LEGEND (ALL CHANGES TO ALL LEVELS)

Note - Detailed internal modifications of the LSH&TM main accommodation building do not form part of this application

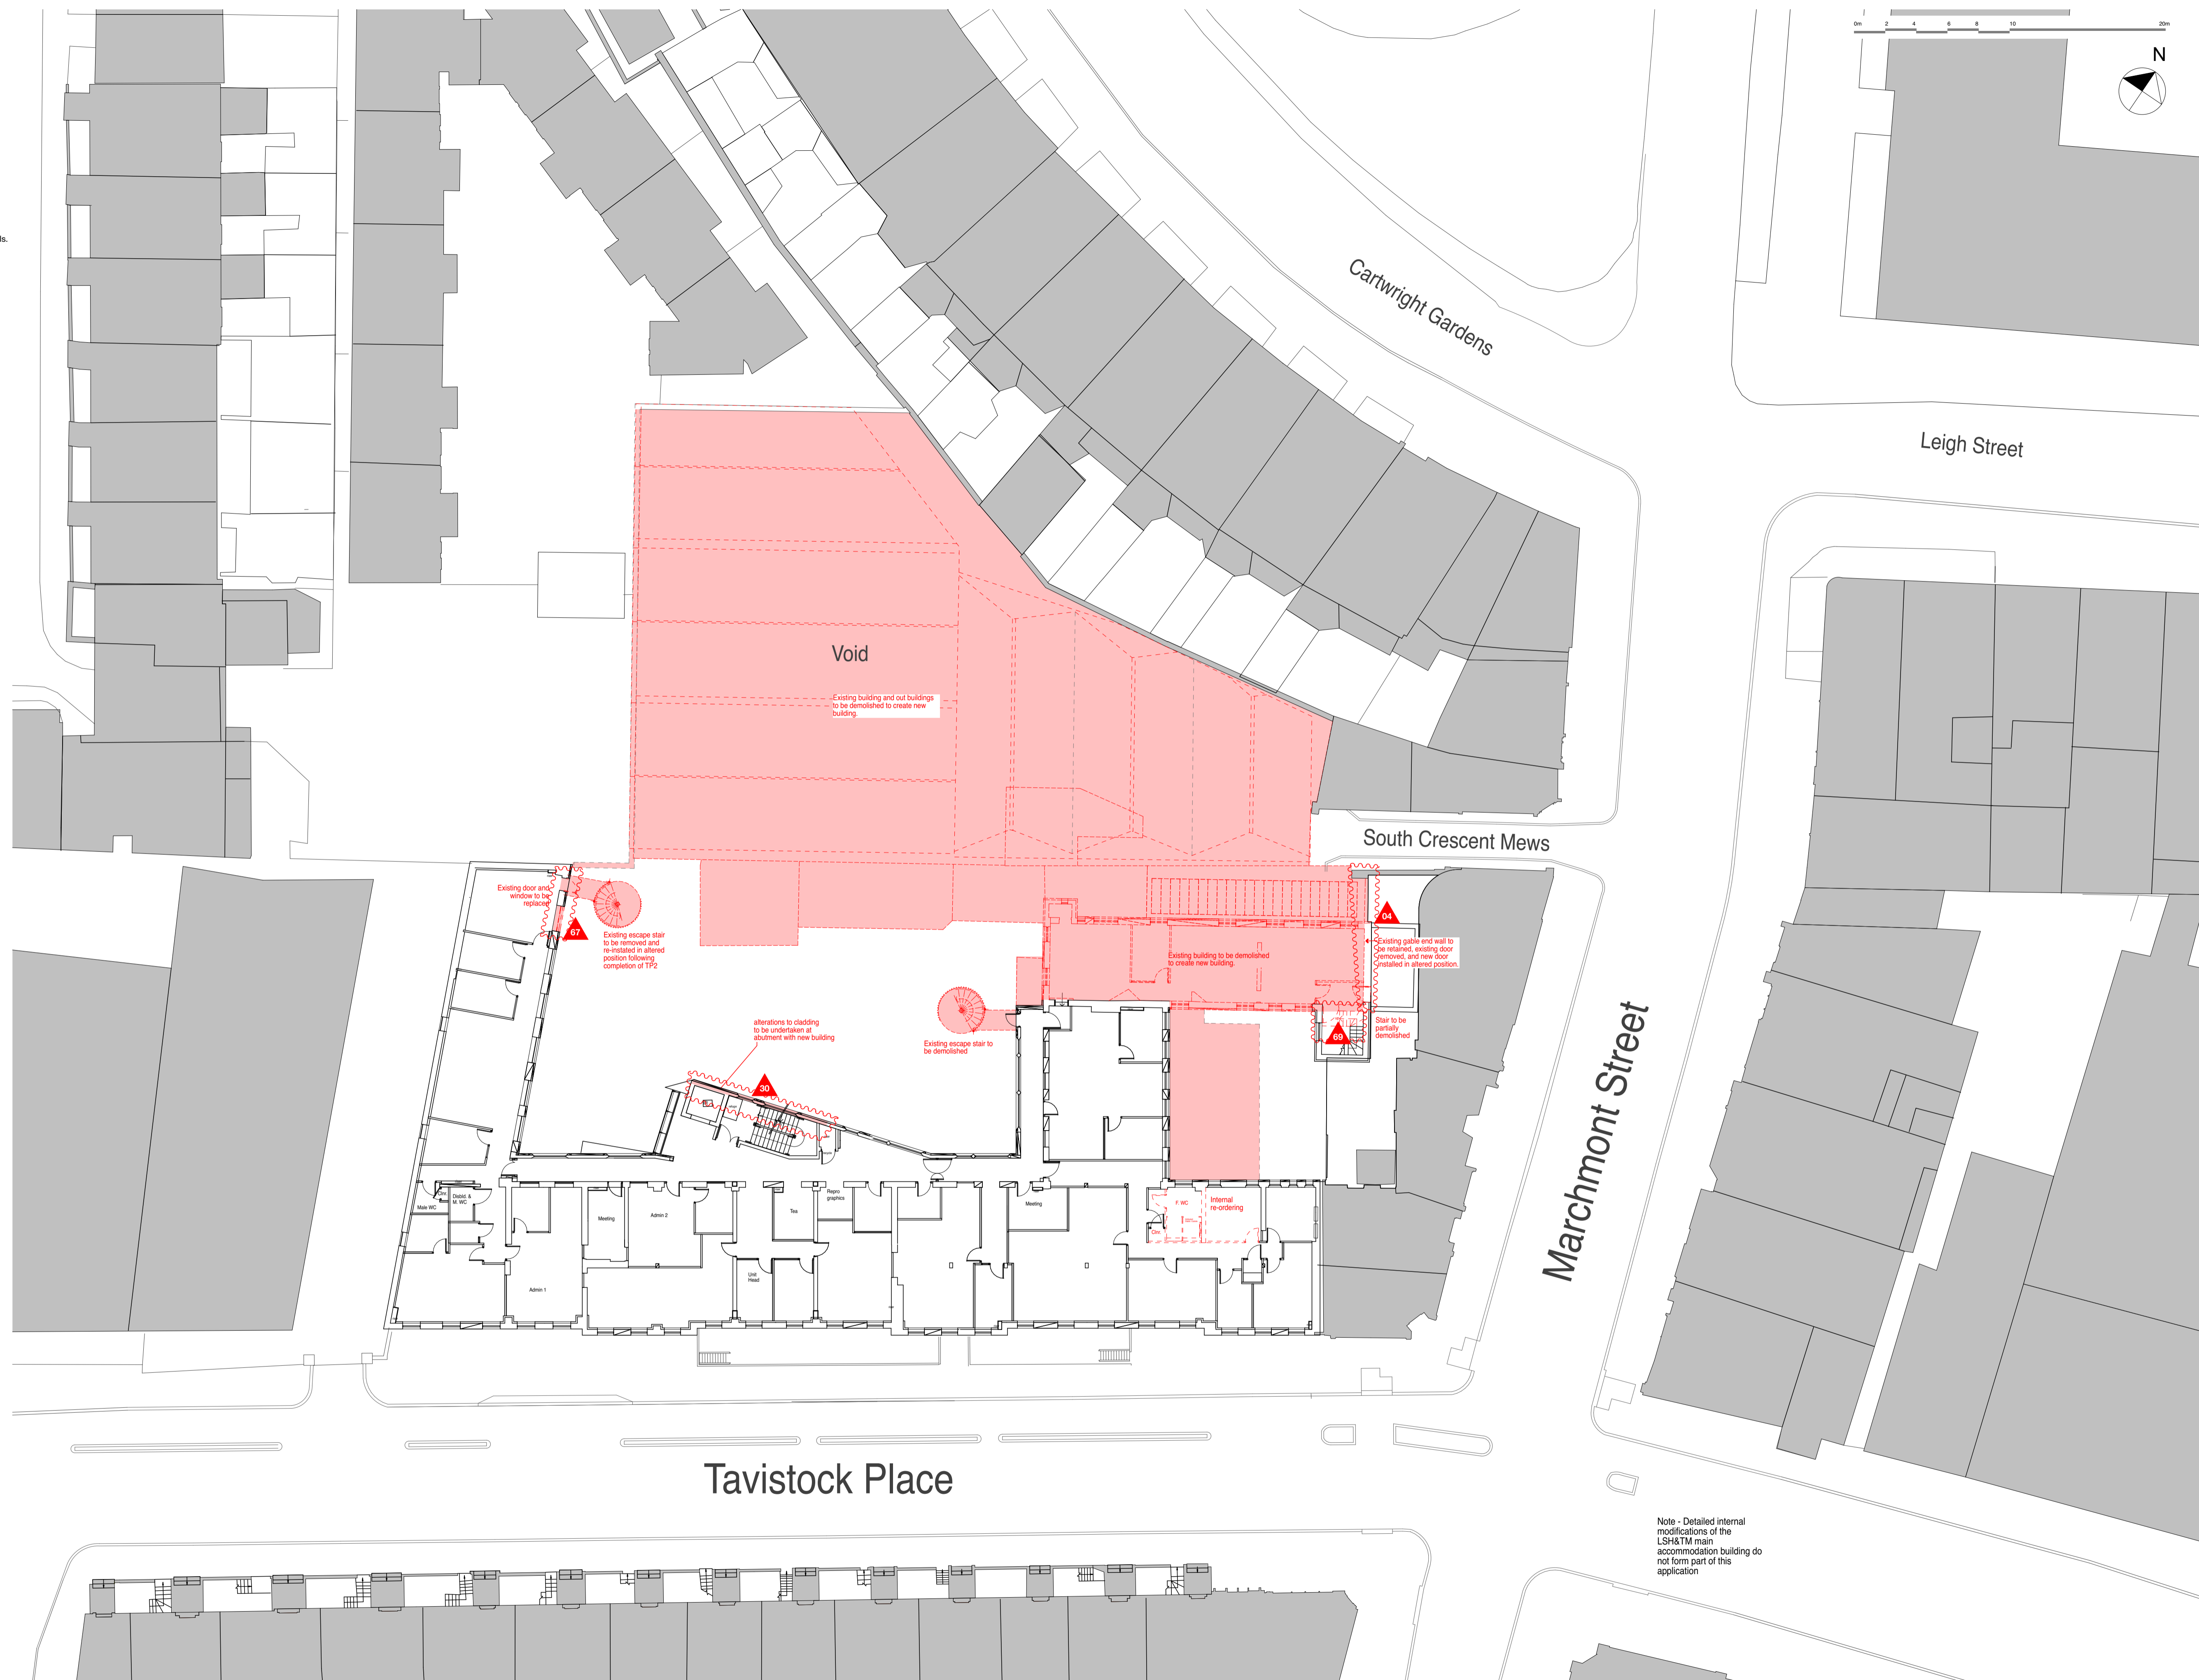
- 01. Stair 2 omitted, and glazed entrance enclosure enlarged
- 02. Window added
- 03. New steps to base of external spiral stair
- 04. Stair 3 roof and gable end arrangement revised.

- 05. Level 3 accommodation mansarded
- 06. Roof light size, height and position adjusted, and smoke vents added.
- 07. Louvres omitted.
- 08. Roof light size, height and position adjusted.

- 09. External ramp adjusted, and railings added.
- 10. West stair core glazing fenestration adjusted to suit amended stair landing levels.
- 11. External paving levels in courtyard raised to achieve required paving falls.

- 12. Low brick plinth added to base of external walls to TP2.
- 13. Brick plinth added to base of existing buildings within courtyard.
- 14. New steps and landing outside room G1.

- 15. Bin store enlarged and repositioned.
- 16. Gallery passageway to TP2: finishes revised.
- 17. Gallery passageway: entrance gates design revised.
- 18. Window on north elevation of TP2 reduced in length.

- 19. Revised turn-table size and position
- 20. Entrance ramp gradient and levels adjusted.
- 21. External levels adjusted
- 22. TP1 west door ramp omitted

- 23. Fall restraint added
- 24. Gates removed
- 25. Maintenance access door added
- 26. Parapet revised
- 27. Roof/wall shape adjusted
- 28. TP1 reception relocated

- 29. Revised door design
- 30. Modifications to windows, doors and facades facing into courtyard.
- 31. Gate details revised
- 32. Revised proposal for bike storage replacing existing bike racks in Dairy shed.

- 33. Gate retained and modified
- 34. Bike canopy detail revised (typical condition highlighted)
- 35. Sub-station doors revised
- 36. Steps adjusted
- 37. Cladding changed to brass finish

- 38. Wall mounted planters revised (typical condition highlighted)
- 39. Steel posts added to boundary wall (typical condition highlighted)
- 40. Height of glazed entrance roof increased to suit required pitch.

- 41. Glazed entrance roof and canopy revised
- 42. New roof guarding to existing flat roof
- 43. Screening fins and cladding added
- 44. Louvres added
- 45. Ramp omitted

- 46. Door removed and infilled
- 47. Access hatch adjusted.
- 48. Depth of green/blue roof build-up adjusted.
- 49. Blue roof incorporated into green roof and gravel margins added.

- 50. Cladding build-up adjusted
- 51. Orientation of brass seams adjusted
- 52. Roof gutters revised.
- 53. Means of escape revisited and exit door added to TP1

- 54. Spiral staircase landings added at each floor
- 55. Door modified
- 56. Basement louvres to external metal staircase landings
- 57. Revised proposal for mean of escape in TP1

- 58. Revised proposal for window and door
- 59. Revised proposal for door to be left as current
- 60. Gate to be removed
- 61. Capping width adjusted and roof planters shown indicatively.

- 62. Door to be replaced
- 63. Revised proposal for the entrance
- 64. Gates and Entrance door in TP1 to be replaced
- 65. Existing stair to be demolished

- 67. Existing window and door to be replaced
- 68. New reconfiguration for new spiral stair and WC
- 69. Staircase partially demolished
- 70. Level adjusted

- 71. Lift pit adjusted
- 72. Level updated
- 73. Red line extended to include South Crescent Mews
- 74. Red line extended to include new ramp and frontage

- 75. Ladder added
- 76. Works to Mews paving/kerbs added
- 77. Minor adjustment to ridge, and eaves line, (not affecting ridge level noted on consented drawings).
